GE Hitachi Nuclear Energy

MFN 08-145

**Subject: Response to NRC Request for Additional Information Letter 131
Related to the ESBWR Design Certification – Radioactive Waste
Management Systems – RAI Numbers 11.2-16S01, 11.2-17
through 11.2-31, 11.3-4 through 11.3-12, 11.4-15S02, 11.4-19
through 11.4-32, and 11.5-48 through 11.5-53**

**Response to Portion of NRC Request for
Additional Information Letter No. 131**

Figure 11.2-1. Liquid Waste Management System Process Diagram

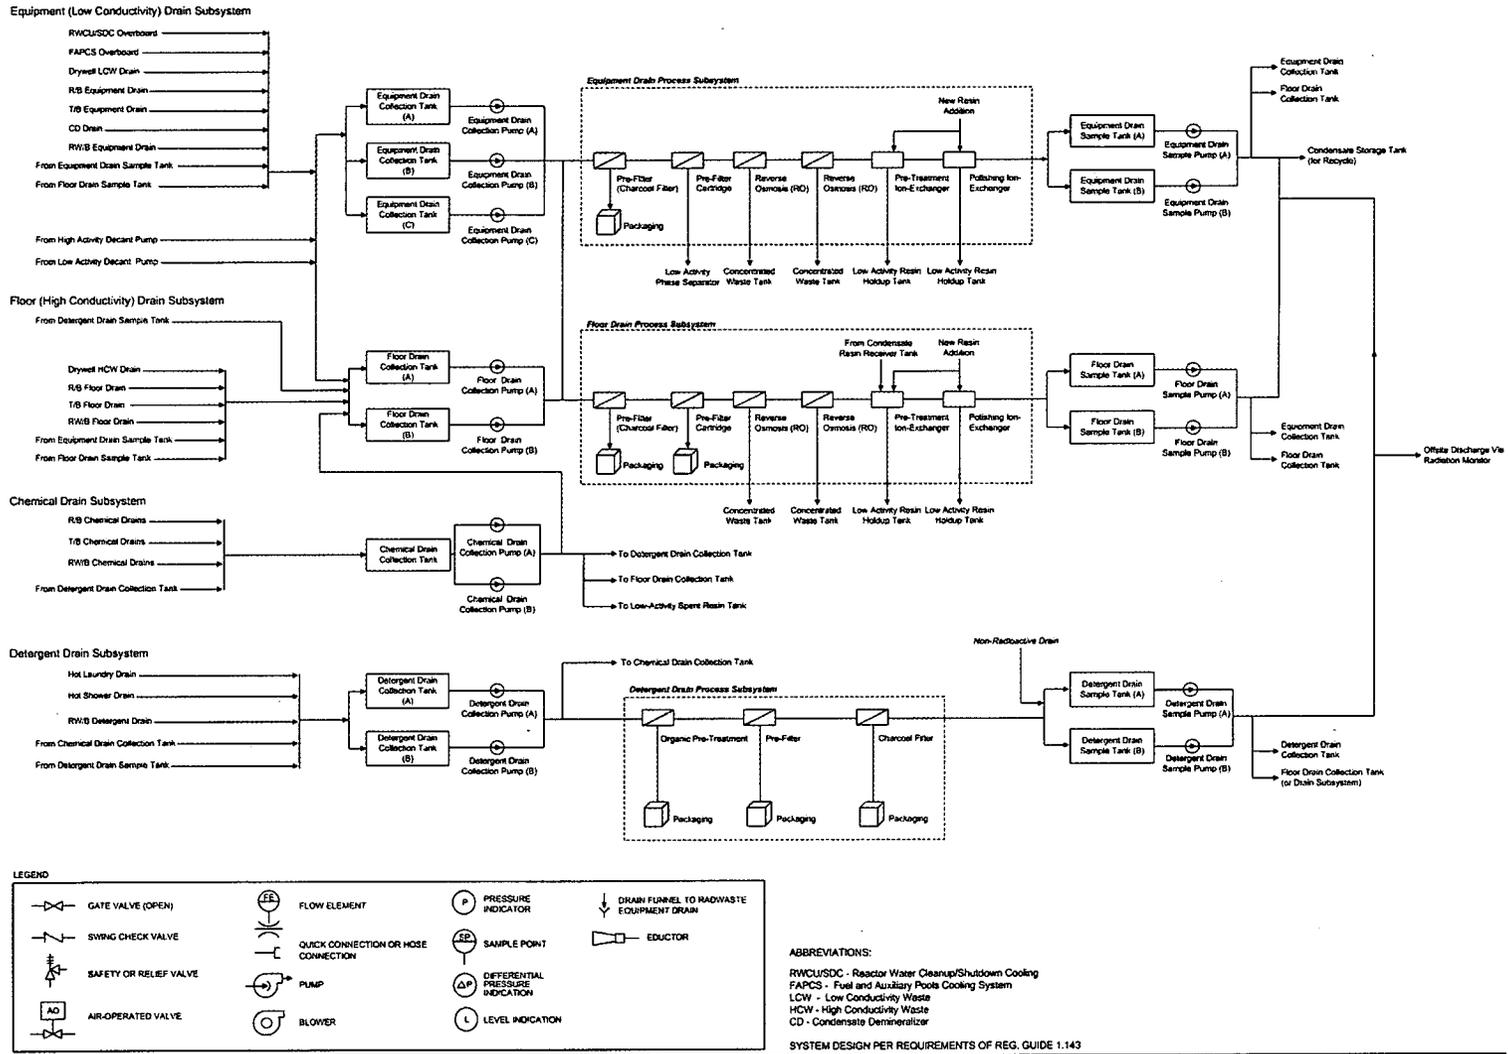
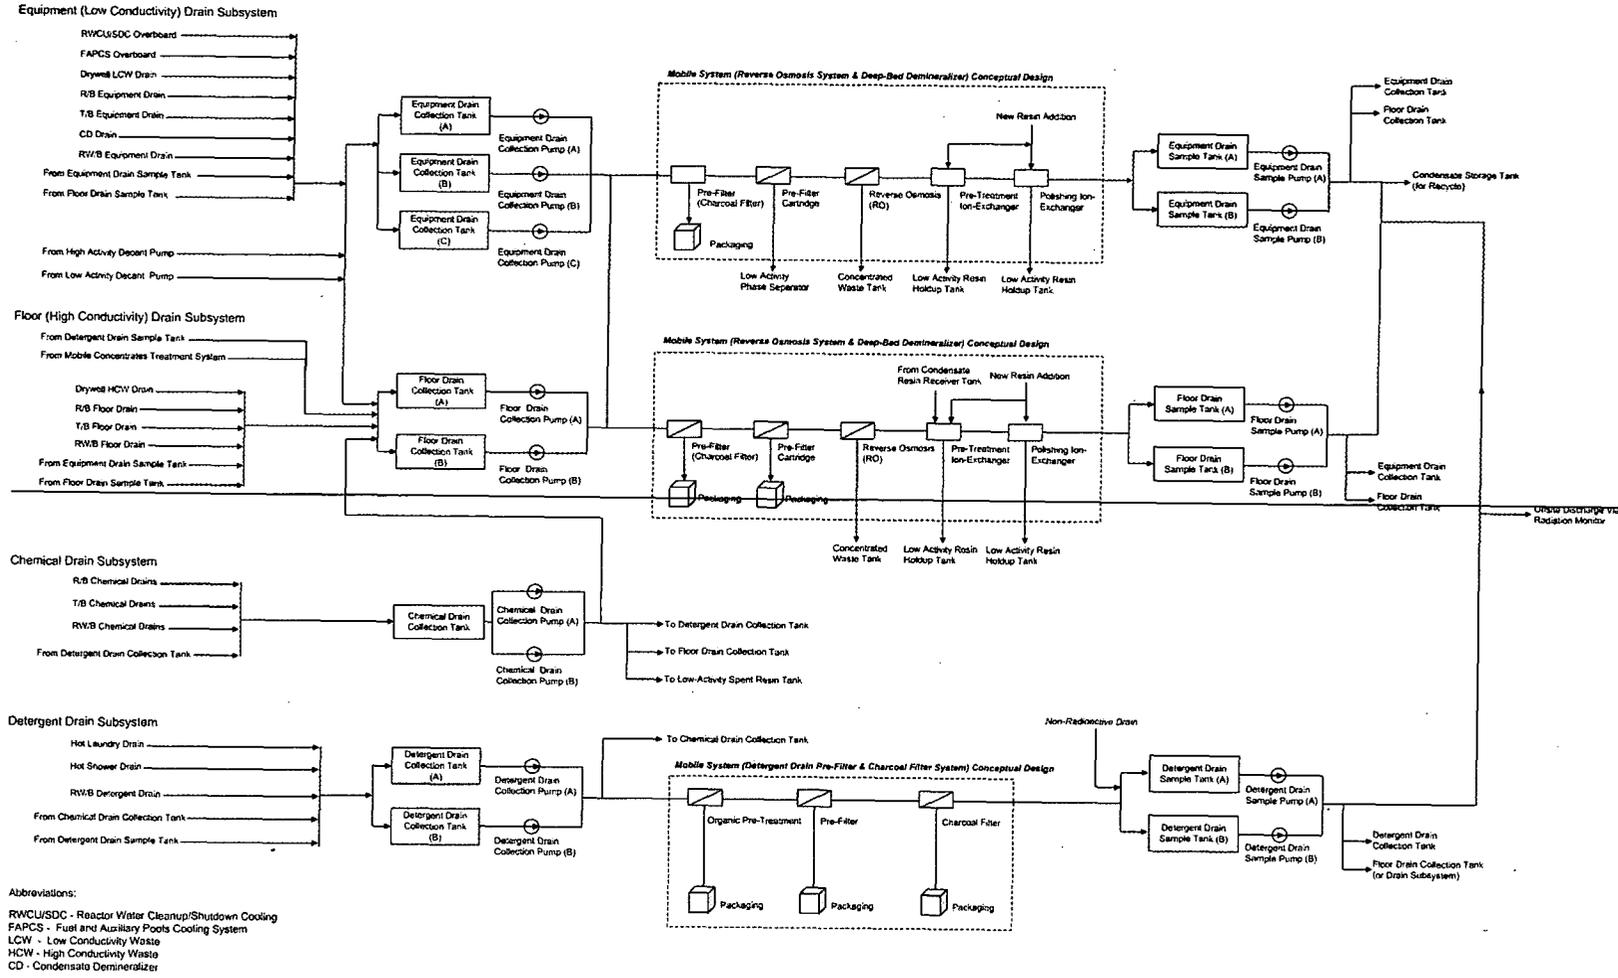
A comparison of DCD, Tier 2, Figure 11.2-1 against Figures 11.2-1a and 11.2-1b indicates an inconsistent number of reverse osmosis (RO) units.

Figure 11.2-1 shows one RO unit each for the Equipment Drain Subsystem and Floor Drain Subsystem, while Figures 11.2-1a and 11.2-1b show two RO units for each. Accordingly, revise DCD, Tier 2 figures to make the functional arrangements of these subsystems internally consistent in DCD, Section 11.2.

A review of DCD, Tier 2, Revision 4, Section 11.2, Figures 11.2-1 to 11.2-4 reveals that legends are missing in explaining the details of the piping drawing for the LWMS. Accordingly, revise DCD Tables 11.2-1 to 11.2-4 to include the appropriate sets of legends for the purpose of interpreting system functional operations.

GEH agrees and will revise DCD Figure 11.2-1 to show two reverse osmosis (RO) units.

DCD Tier 2, Figure 11.2-1 will be revised as noted on the attached markup.

Figure 11.2-1a. Equipment Drain

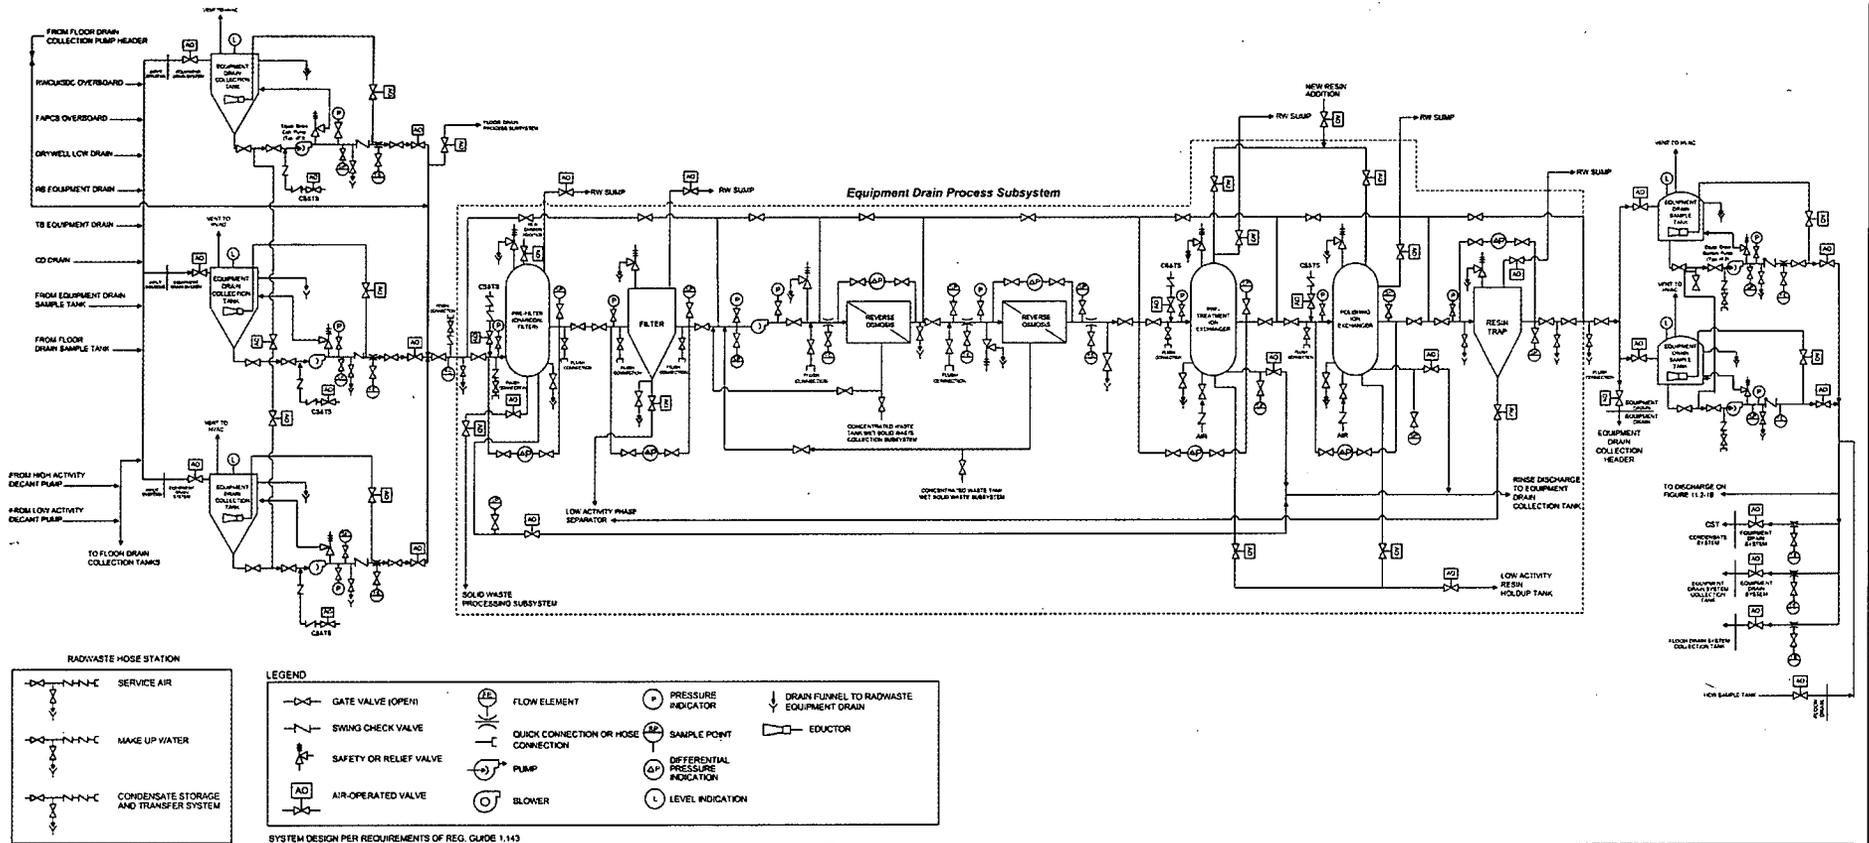
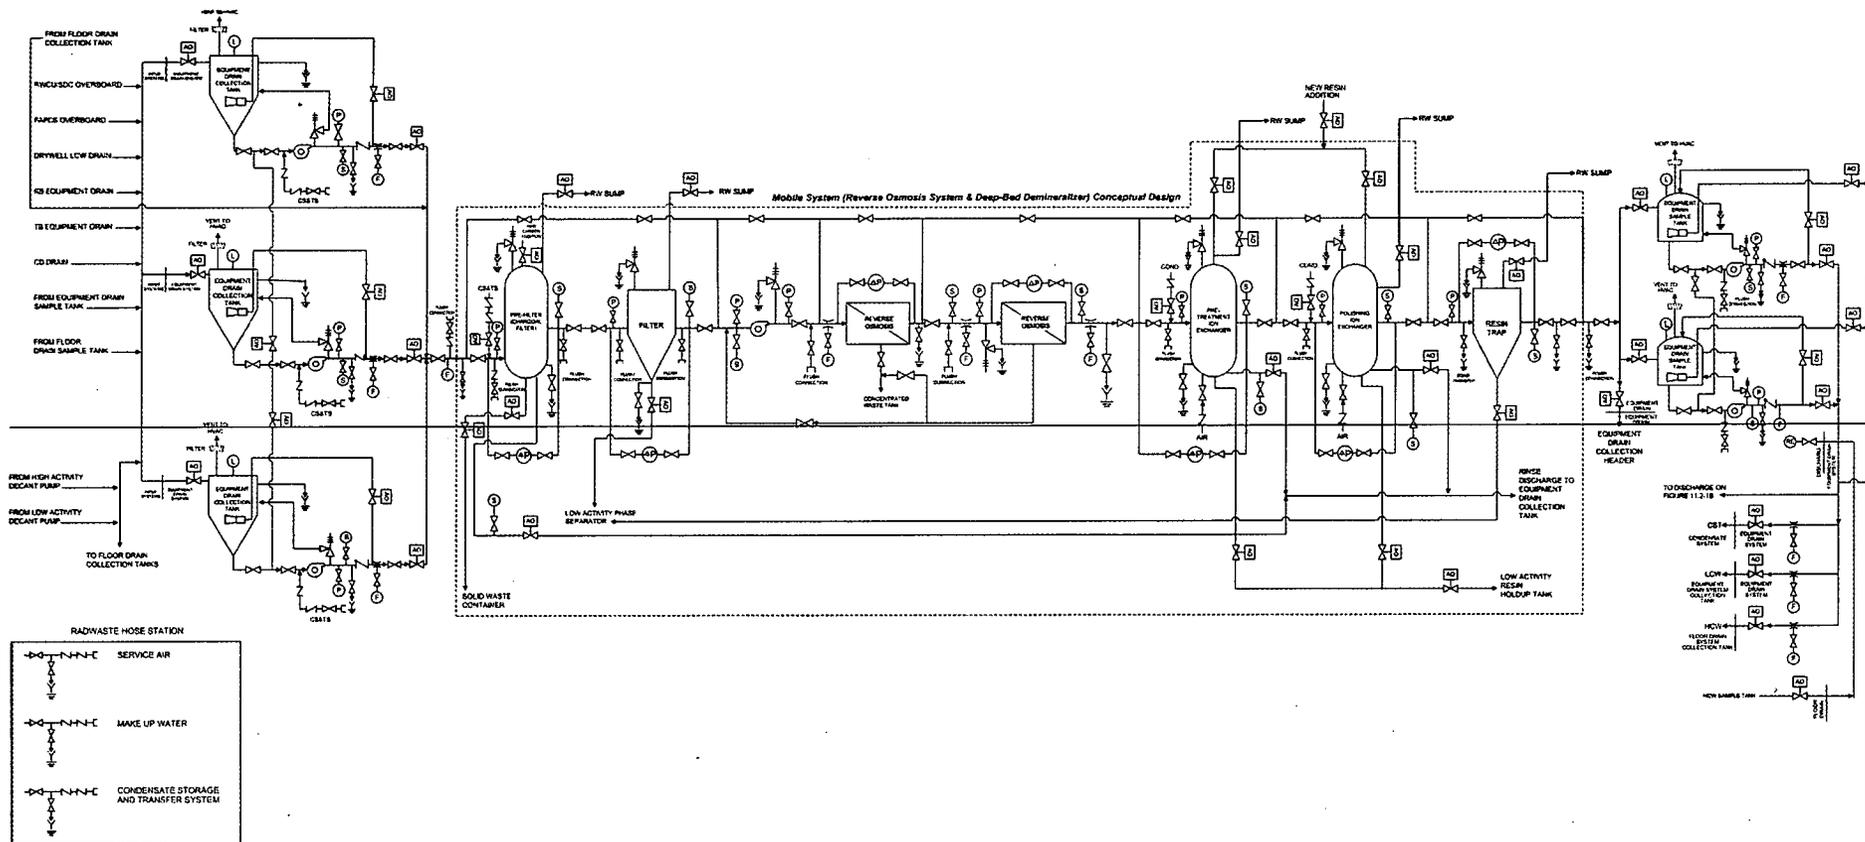
DCD, Tier 2, Figures 11.2-1a, 11.2-1b, 11.2-3, and 11.2-4 show overflows and drain funnels with no end dispositions. Revise the above listed figures to provide the disposition or endpoints of these overflows. If it is to a tank/sump, then include sump/tank size, pump flow rate capability, and where the sump/tank will flow or be pumped to, such as which subsystem components. Address the above issues and update DCD, Tier 2, Section 11.2 tables and text accordingly.

GEH agrees with the staff's findings that DCD, Tier 2, Figures 11.2-1a, 11.2-1b, 11.2-3, and 11.2-4 show overflows and drain funnels with no end dispositions. DCD, Tier 2, Figures 11.2-1a, 11.2-1b, 11.2-3, and 11.2-4 will be revised adding drain funnels showing destinations to floor and equipment drains. The power generation design basis of floor and equipment drains is described DCD, Tier 2, Section 9.3.3.1 that states: "Drainage systems are designed to accommodate the maximum anticipated normal volumes of liquid without overflowing including such inputs as the anticipated water flow from a fire hose and other fire suppression water discharges to the area floor drains without impacting the safety function of any safety-related component or system. However, as delineated in Subsection 3.4.1.3, no credit is taken for the drainage system in the flooding analysis." Sump/tank size, pump flow rate capability, and where the sump/tank will flow or be pumped to, such as which subsystem components, will not be added to DCD, Tier 2, Section 11.

DCD, Tier 2, Figures 11.2-1a, 11.2-1b, 11.2-3, and 11.2-4, will be revised as noted on the attached markup.

Figure 11.2-4. Chemical Drain

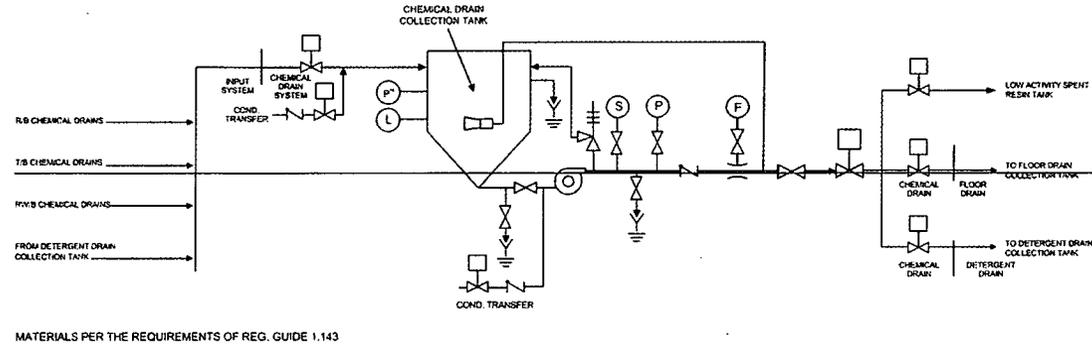
A review of DCD, Tier 2, Figure 11.2-4 shows that the Chemical Drain Collection Tank is not equipped with a vent. Accordingly, justify the omission of a vent for this tank or update DCD, Tier 2, Figure 11.2-4 to include a vent in its design.

DCD, Tier 2, Revision 4, Section 11.2, Table 11.2-2b and Figure 11.2-4 show an inconsistent number of pumps. DCD Table 11.2-2b lists two (2 pumps for the chemical drain system but Figure 11.2-4 shows only one. Accordingly, update the table and figure for consistency in listing the number of pumps.

GEH concurs with the staff finding and will update DCD, Tier 2, Figure 11.2-4 to include a vent in the design.

DCD Tier 2, Figure 11.2-4 will be revised as noted on the attached markup.

GEH concurs with the staff finding and will update DCD, Tier 2, Revision 4, Section 11.2, Figure 11.2-4 to show 2 chemical drain pumps.

DCD, Tier 2, Section 11.2, Figure 11.2-4 will be revised as noted on the attached markup.

Figure 11.4-1. Solid Waste Management System Process Diagram

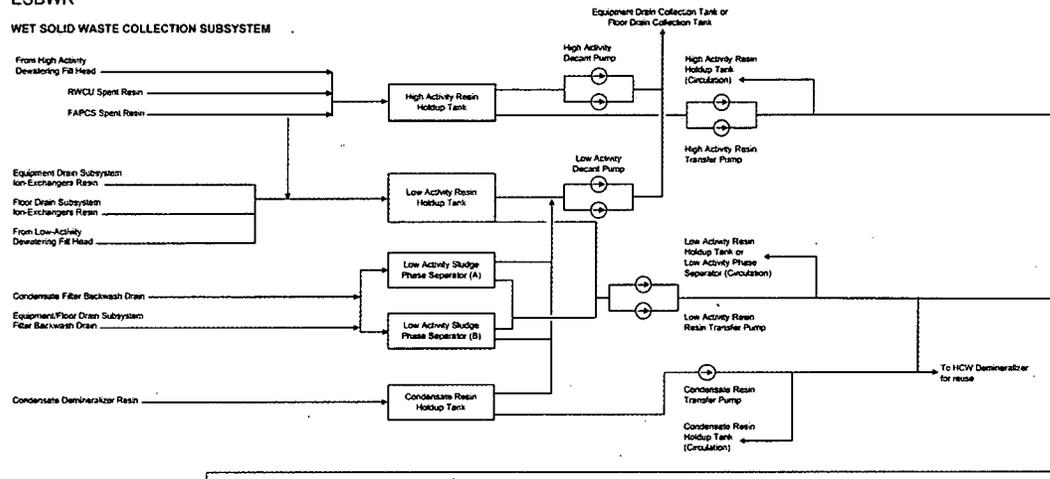
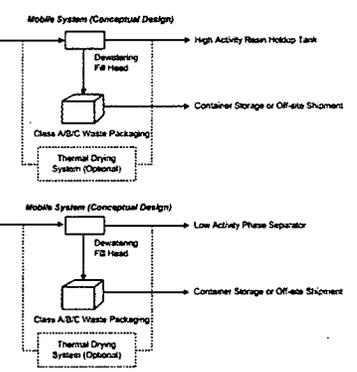
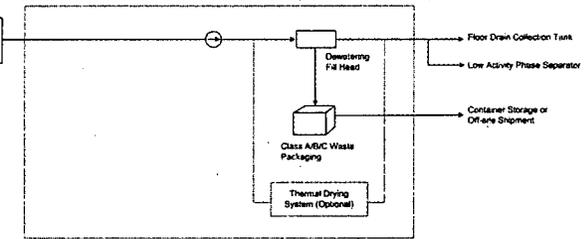
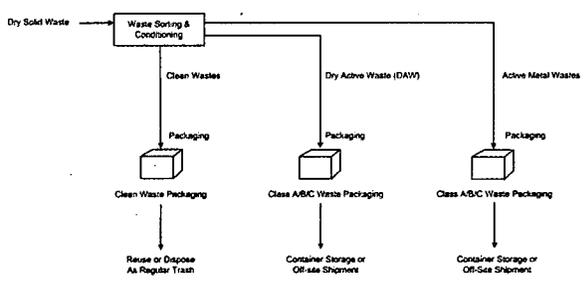
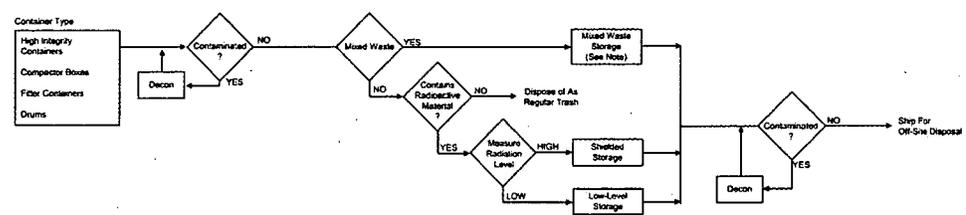
Throughout DCD, Tier 2, Chapter 11.4, the phase separators are referred to as "Low Activity Phase Separators", but Figure 11.4-1, Solid Waste Management System Process Diagram, refers to the phase separator as "Low Activity Sludge Phase Separators." Address this inconsistency in terminology and revise DCD, Tier 2, Section 11.4 and associated figures accordingly.

GEH agrees with the inconsistency identified by the staff. DCD, Tier 2, Chapter 11.4, Figure 11.4-1, Solid Waste Management System Process Diagram, wording will be revised to reflect "Low Activity Phase Separators."

DCD, Tier 2, Chapter 11.4, Figure 11.4-1 will be revised as noted on the attached markup.

Figure 11.4-2. SWMS Spent Resin Sludge Transfer System Wet Solid Waste Collection Subsystem

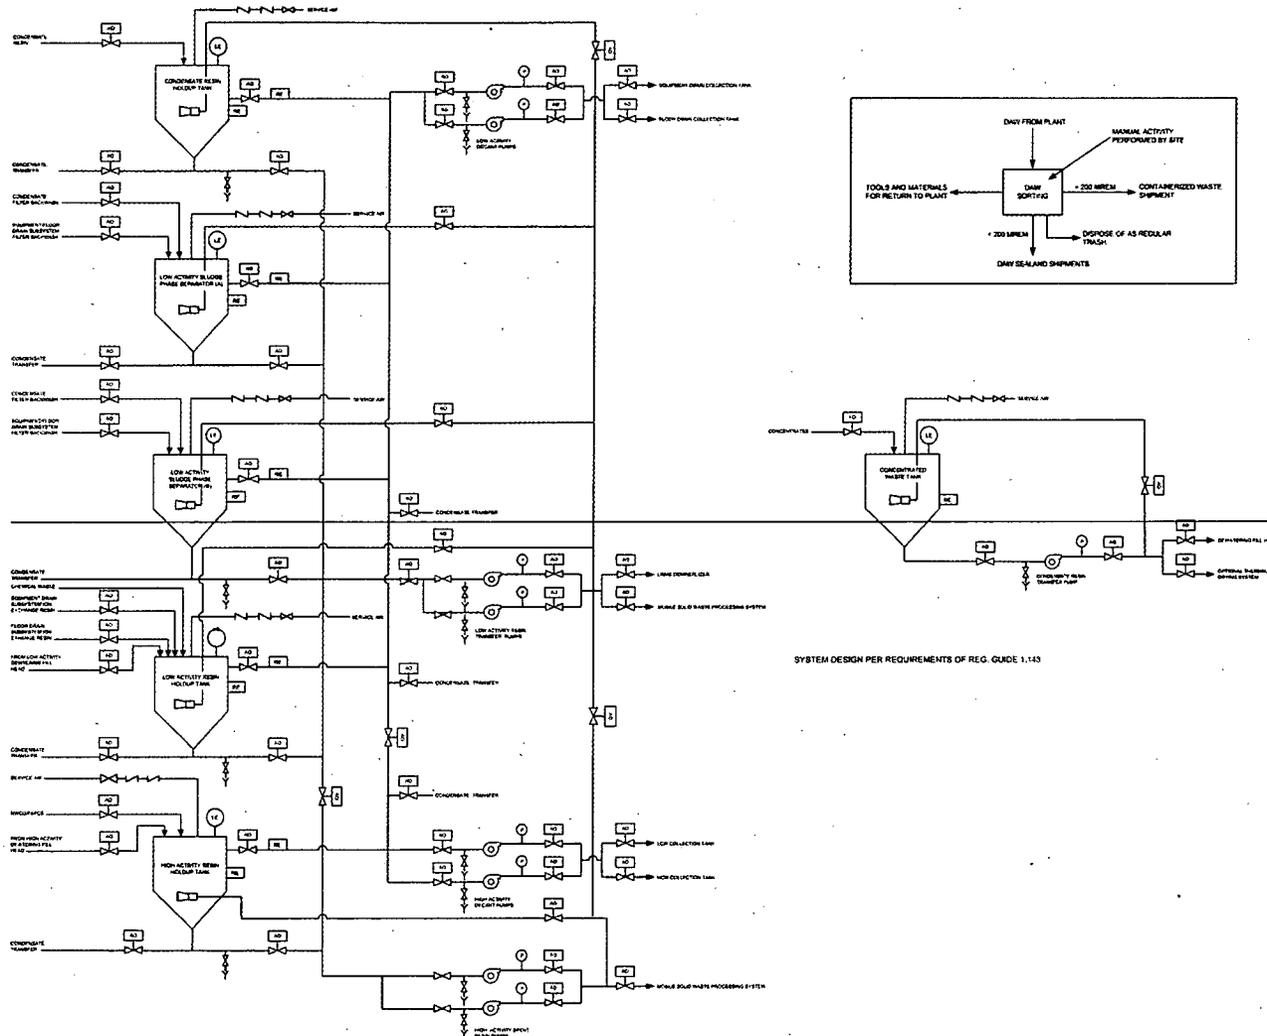
DCD, Tier 2, Figure 11.4-2 includes Sample Point in the legend box, but none are noted in the system drawing. Provide the technical rationale for not including sampling points. Note that waste products processed by this subsystem will need to be characterized in determining compliance with the waste form characteristics of 10 CFR Part 61.55 and 61.56 and waste acceptance criteria of the radwaste disposal site. If sampling points are not included by design in this subsystem, describe alternate means for sampling waste streams and products from this subsystem in DCD, Tier 2, Sections 11.4.2.2 and 11.4.6 (COL information Item 11.4-3-A, Process Control Program).

DCD, Tier 2, and Figure 11.4-2 shows the Concentrated Waste Tank being pumped to the Solid Waste Processing Subsystem, yet Figure 11.4-3 does not show this input. Figure 11.4-1 shows an input to the Low Activity Resin Holdup Tank from Concentrated Waste, yet Figure 11.4-2 does not show this input. Address these discrepancies in system flow paths and revised tank. DCD, Tier 2, Section 11.4.2 and associated figures accordingly.

In DCD, Tier 2, Figure 11.4-2, the horizontal line coming from the bottom of Phase Separator (A) ends abruptly with no connections to other portions of the system. The vertical line coming from the bottom of the Condensate Resin Holdup Tank, after the second air-operated valve, ends abruptly as well. Address these inconsistencies in system flow paths and revise DCD, Tier 2, Figure 11.4-2 accordingly.

DCD, Tier 2, Figure 11.4-2 identifies the presence of 11 radiation monitors (see symbol RE in figure), but DCD, Tier 2, Sections 11.4.5, 11.5.3, and 12.3 (Table 12.3-4) do not describe such radiation monitors. The radiation monitors are shown to be mounted on tanks/vessels and subsystem piping. The description and operational functions of the radiation monitors are not described in the proposed revision of DCD, Tier 2, Section 11.4. Confirm whether such radiation monitors are part of the design; if so, provide information about their operational functions; and revise DCD, Tier 2, Sections 11.4.5, 11.5.3, and 12.3, and associated tables and figures.

GEH concurs with the staff and will revise DCD, Tier 2, Figure 11.4-2 to include Sample Points for waste products processed by this subsystem to enable characterizing waste for compliance to 10 CFR Part 61.55 and 61.56, and waste acceptance criteria of the radwaste disposal site.

GEH concurs with the discrepancy identified by the staff. DCD, Tier 2, Figure 11.4-2 will show the Concentrated Waste Tank being pumped to the Solid Waste Processing Subsystem (Figure 11.4-3 now shows this input). Figure 11.4-2 now shows an input from the concentrated waste tank.

GEH agrees that the drawing inconsistency exists and will correct the drawing inconsistencies in system flow paths and revise DCD, Tier 2, Figure 11.4-2 accordingly.

GEH agrees the radiation monitors shown on DCD, Tier 2, Figure 11.4-2 are not described or identified in DCD, Tier 2, Sections 11.4.5, 11.5.3, and 12.3, and associated tables and figures. DCD, Tier 2, Figure 11.4-2 will be revised to delete these radiation monitors as they are no longer part of the design. These monitors were previously added for operational convenience and are not required to perform a safety or operational function described in Chapter 11.
